APPEAL SUMMARY

Appeal ID: 20546	Project Address: 1600 SW Salmon St
Hearing Date: 6/19/19	Appellant Name: Tom Jaleski
Case No.: B-017	Appellant Phone: 503.488.5651
Appeal Type: Building	Plans Examiner/Inspector: Jody Orrison
Project Type: commercial	Stories: 6 Occupancy: A-2, A-3, B, E, S-1 Construction Type: I-B
Building/Business Name: Lincoln High School	Fire Sprinklers: Yes - Throughout
Appeal Involves: Erection of a new structure	LUR or Permit Application No.:
Plan Submitted Option: pdf [File 1] [File 2]	Proposed use: High School - Main Building

APPEAL INFORMATION SHEET

LINCOLN HIGH SCHOOL REPLACEMENT

Copyright 17011
100% DESIGN
DEVELOPMENT
STAIR 1 ENLARGED
PLANS

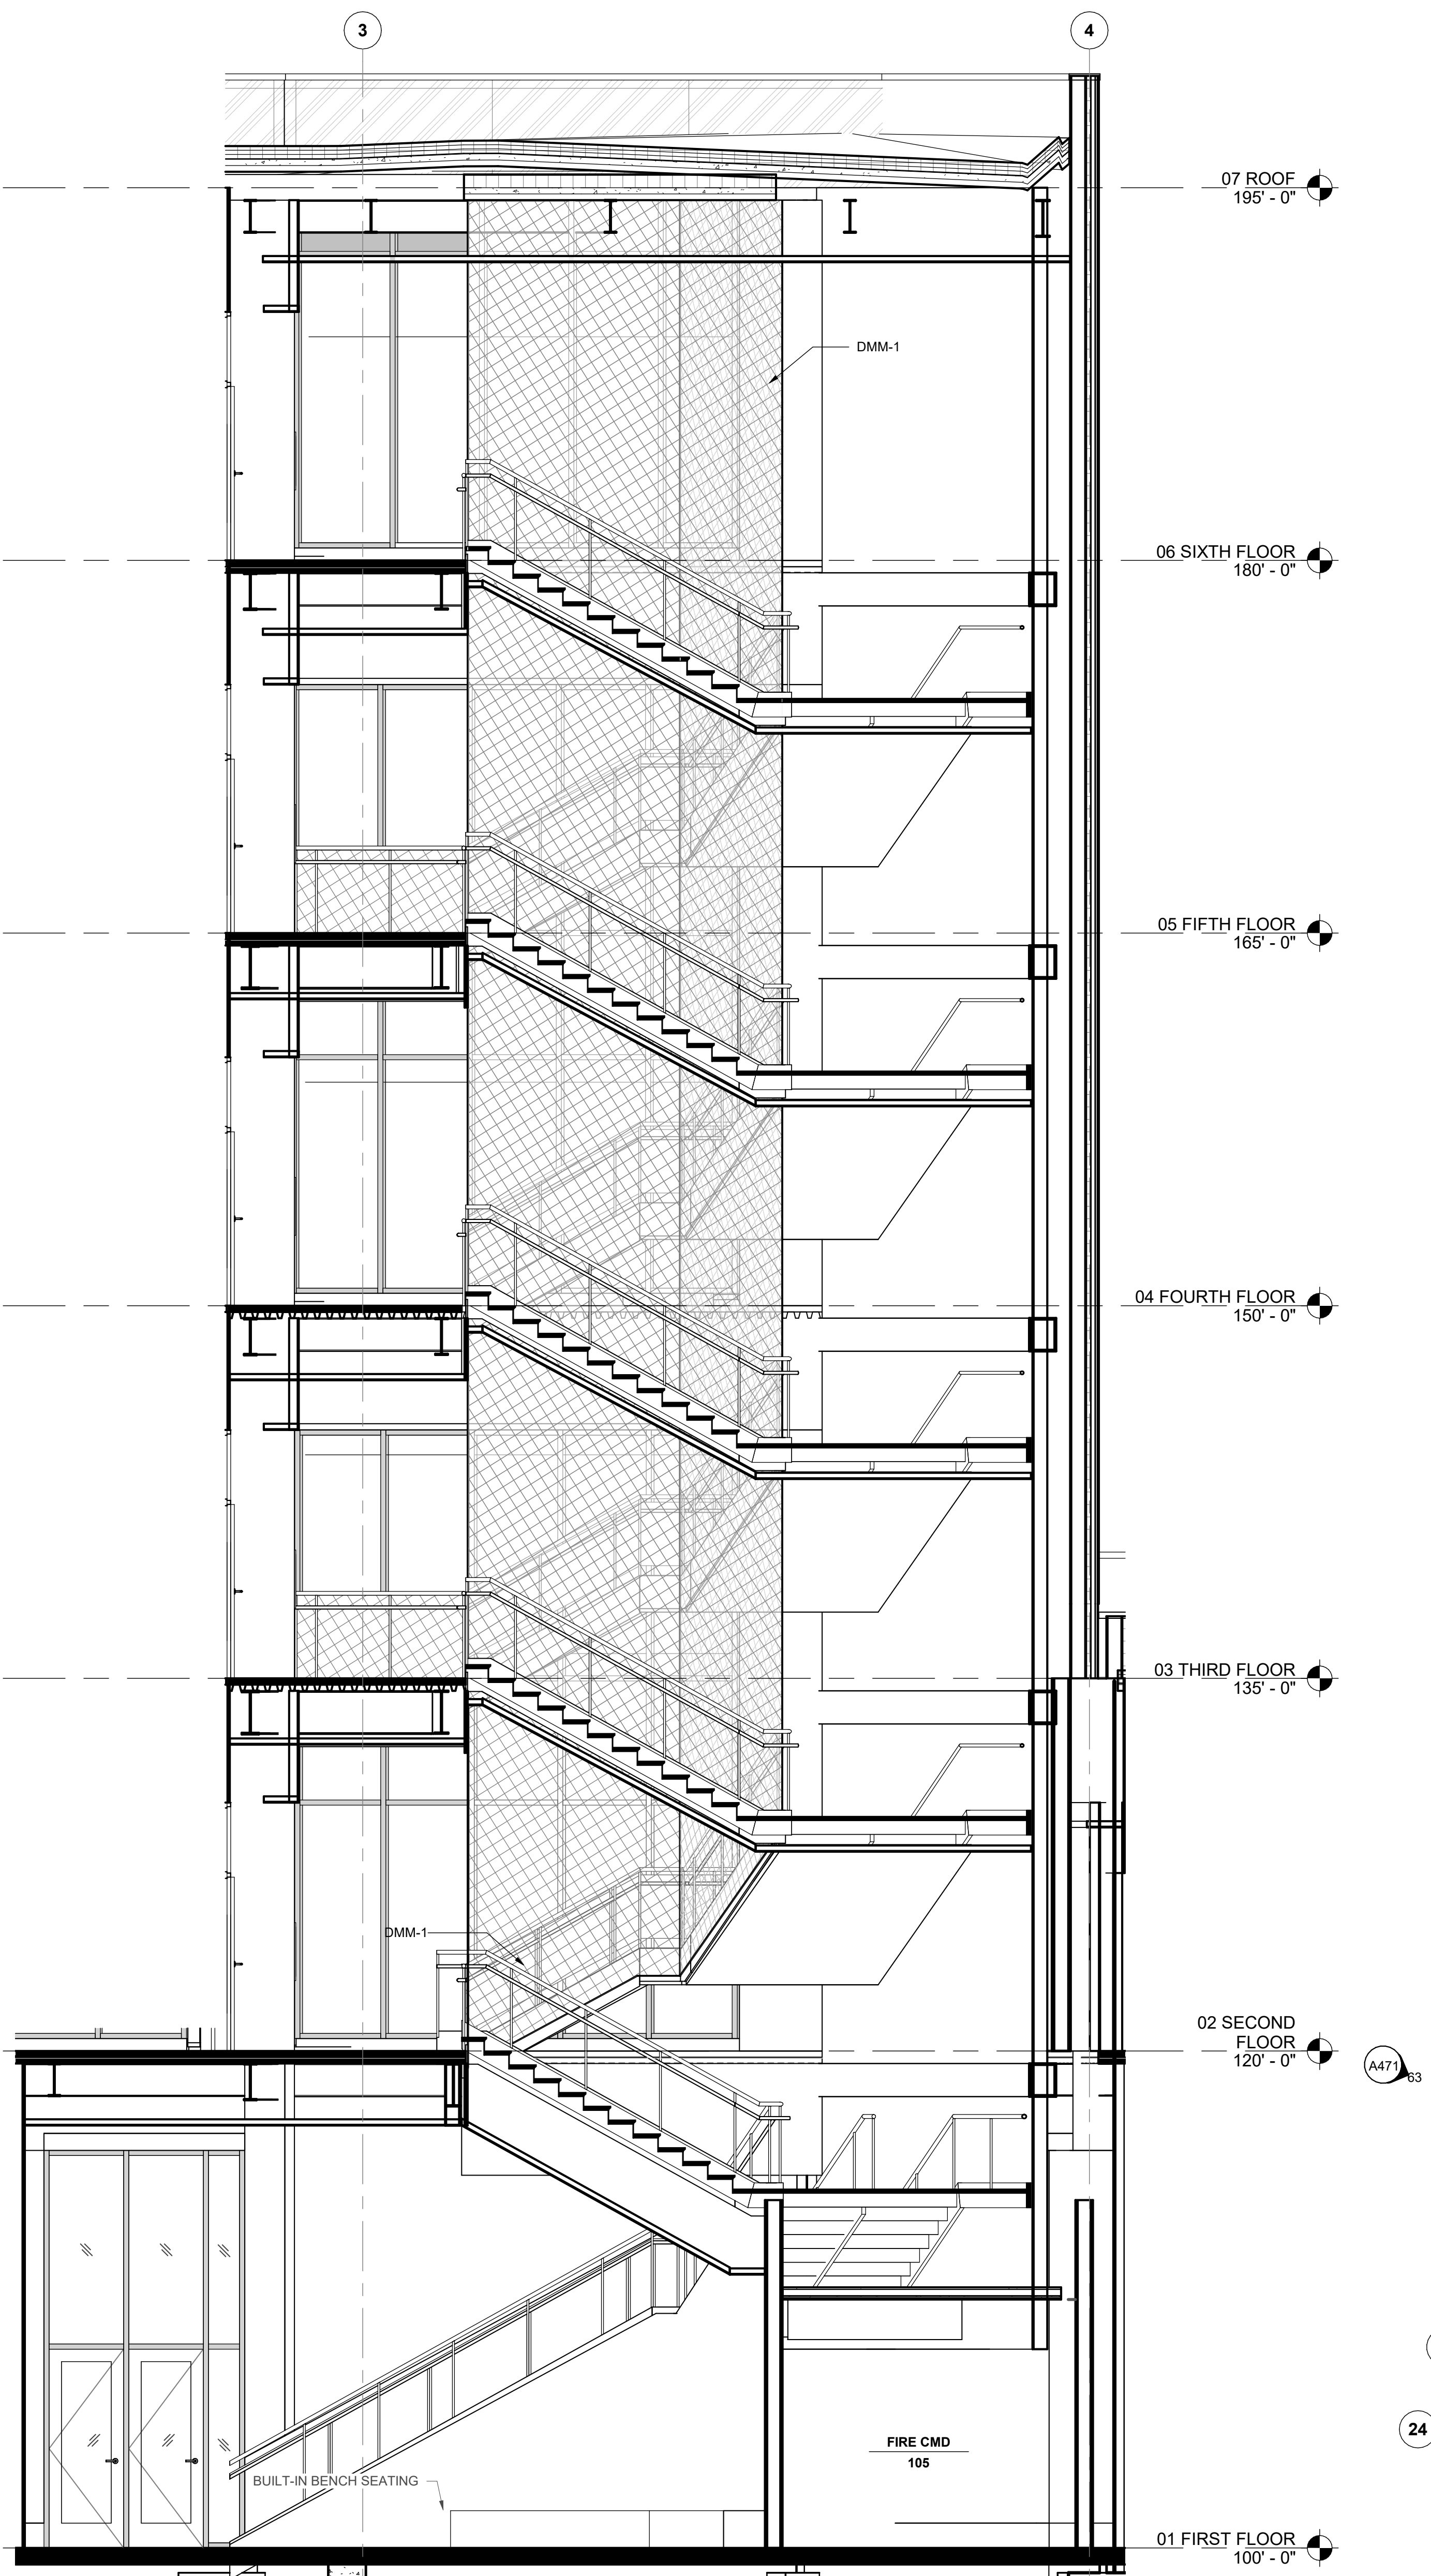
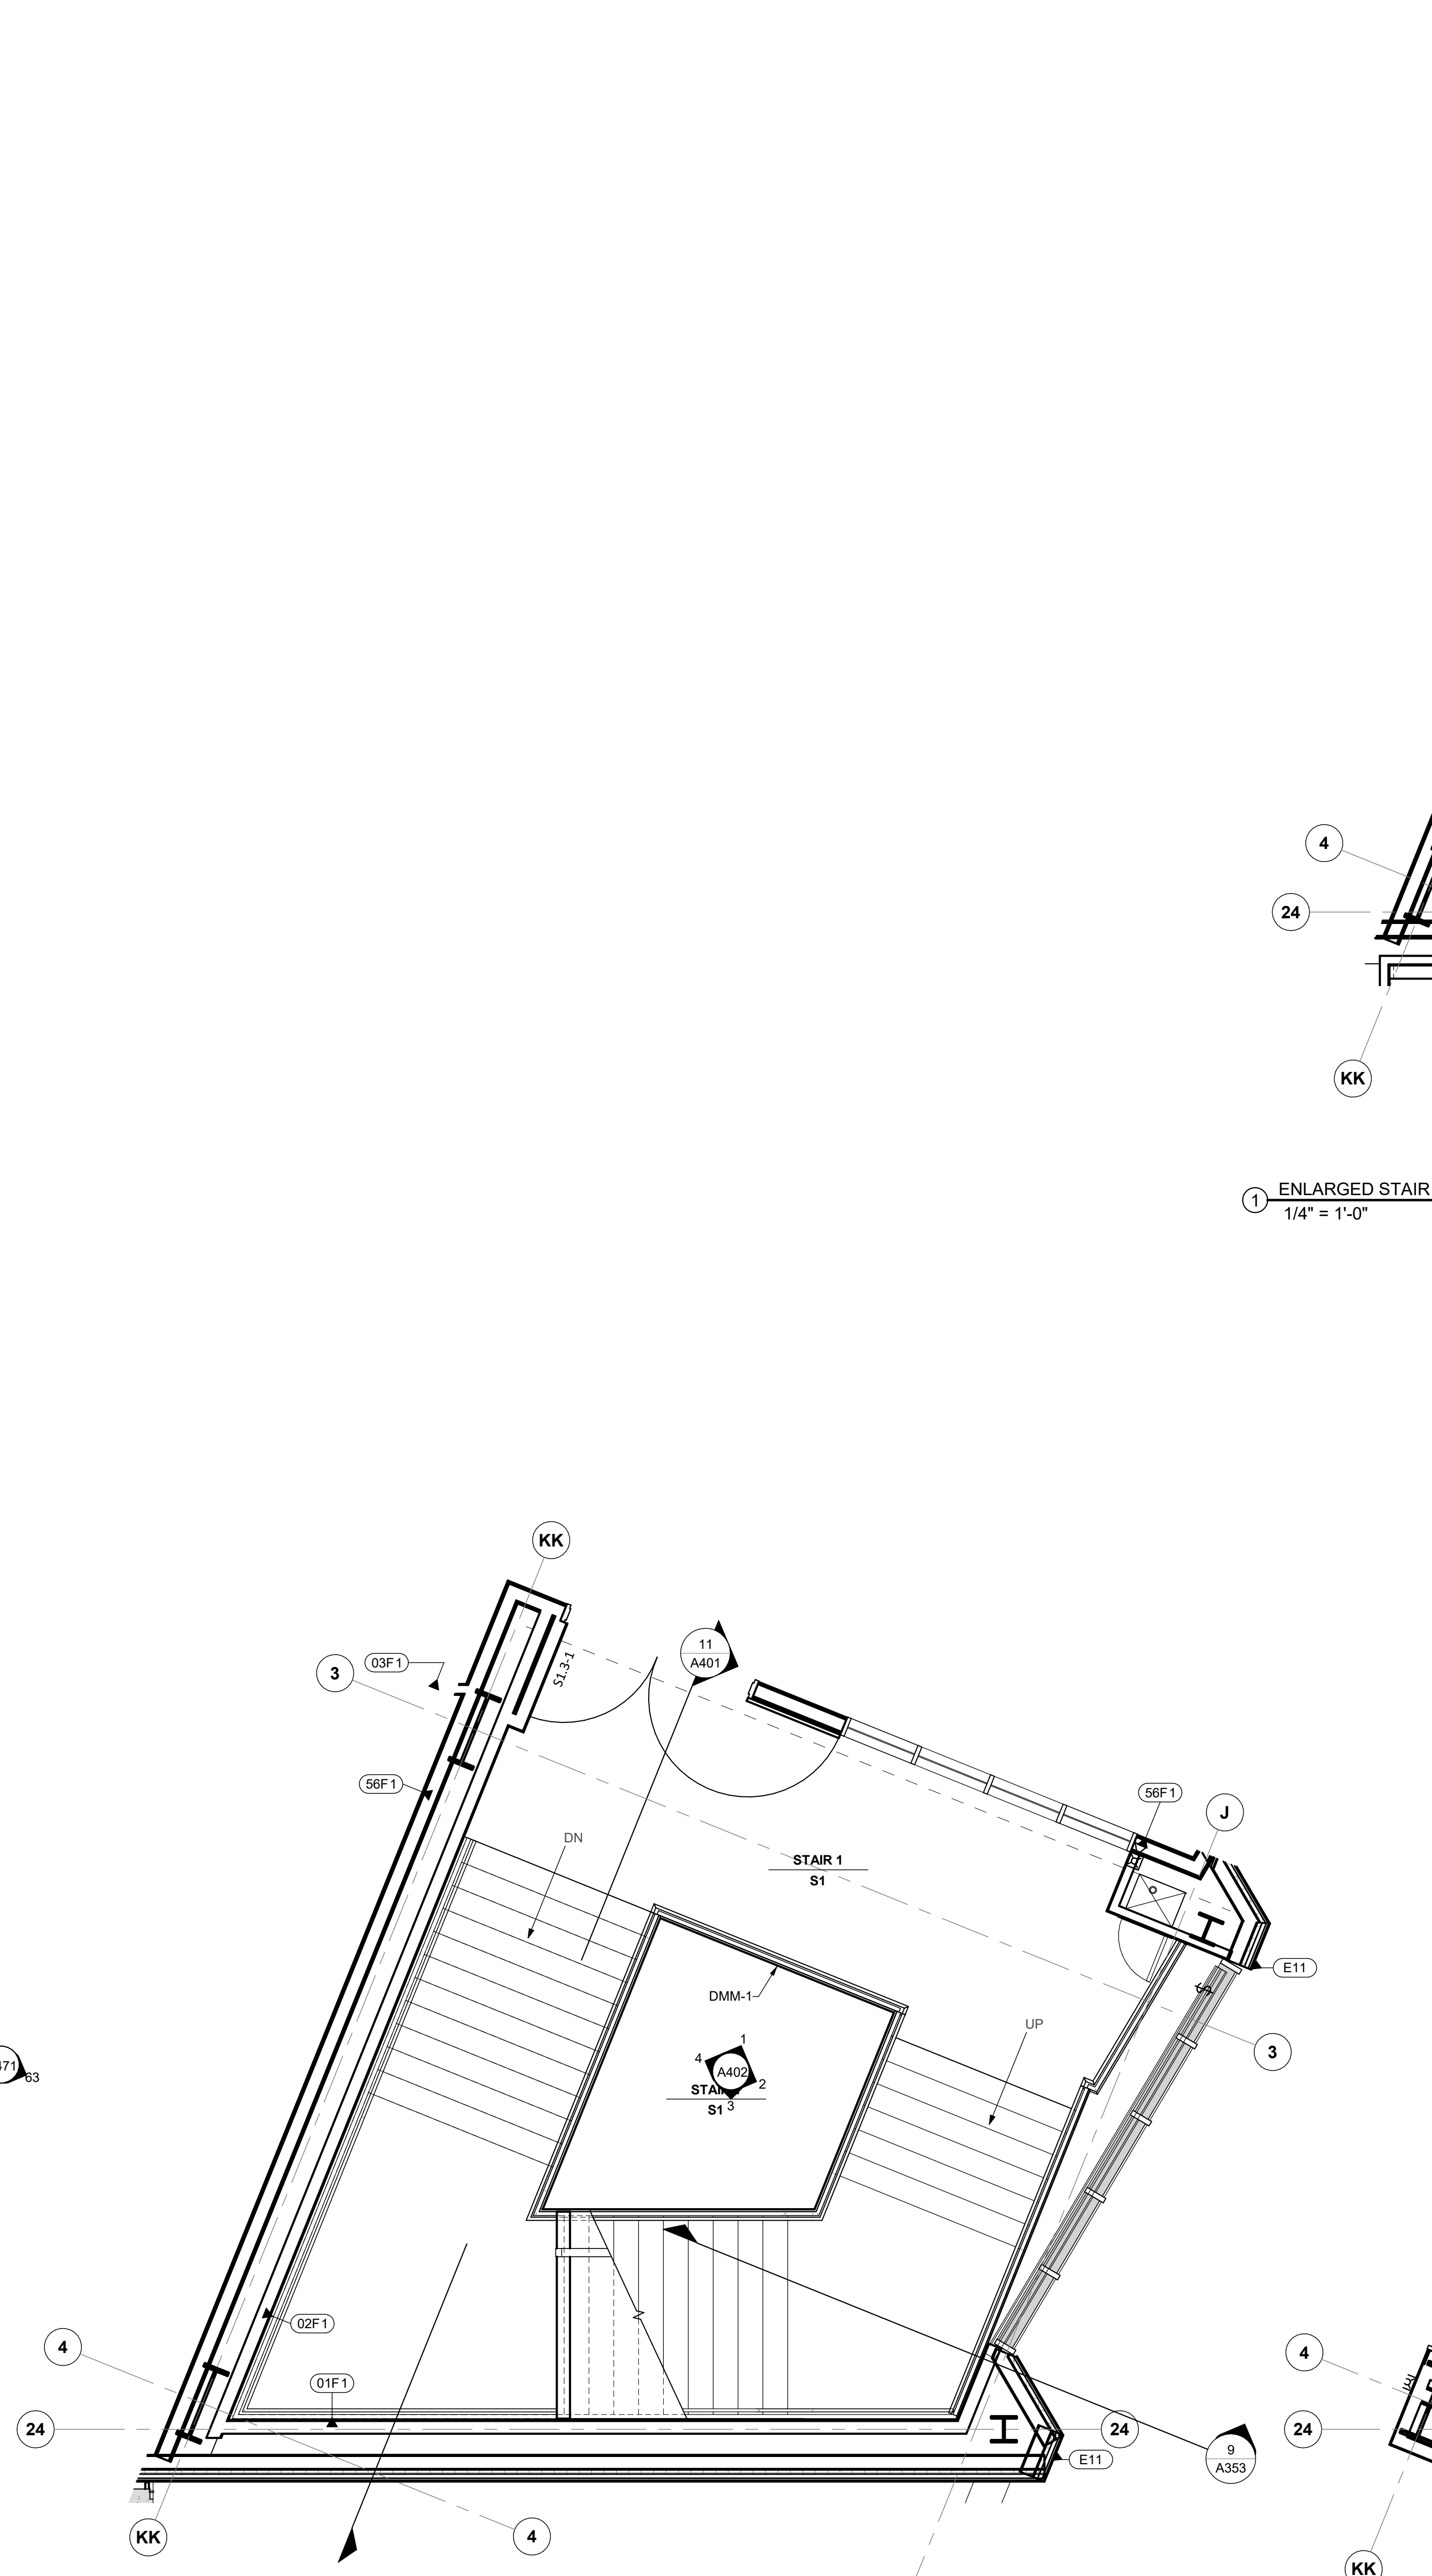
Stair 1:

- CONDITION: Six-story interior exit stairway.
- RATING: 2-hour fire-resistance-rated enclosure.
- EGRESS: Two (2) egress doors from enclosure direct to the exterior.

- o Two openings located on west wall of enclosure at Level 01.
- o Each protected with a 3-hour fire shutter meeting UL 10B (equivalent) and UL 1784, and provided with an automatic-closing device and smoke detection.
- o Both shutters are 11-ft wide by 12-ft tall (132 sf).
- o One of the shutters will include a 3-ft wide by 8-ft tall integral person door.

2b. The 3-hour fire-resistance-rated fire shutters located on the west wall of the Stair 4 enclosure and on the west wall of the Stair 1 are not prescriptively allowed. The shutters will provide equivalent fire life safety as compared to the code requirements of a stairway enclosure in a fire event by meeting, and in some requirements exceeding, the opening protective provisions of Chapter 7 as follows:

Therefore, due to equivalent life safety protection being provided to meet the intent of §1009.3.1.4.1 and §1022.4, it is requested that the two (2) openings in Stair 1 and the two (2) openings in Stair 4 be permitted when protected with a 3-hour fire-resistance-rated fire shutter or 2-hour fire glass as identified in the proposed design.

2. Openings in (2) two hour fire rated stair enclosures: Hold for additional information.
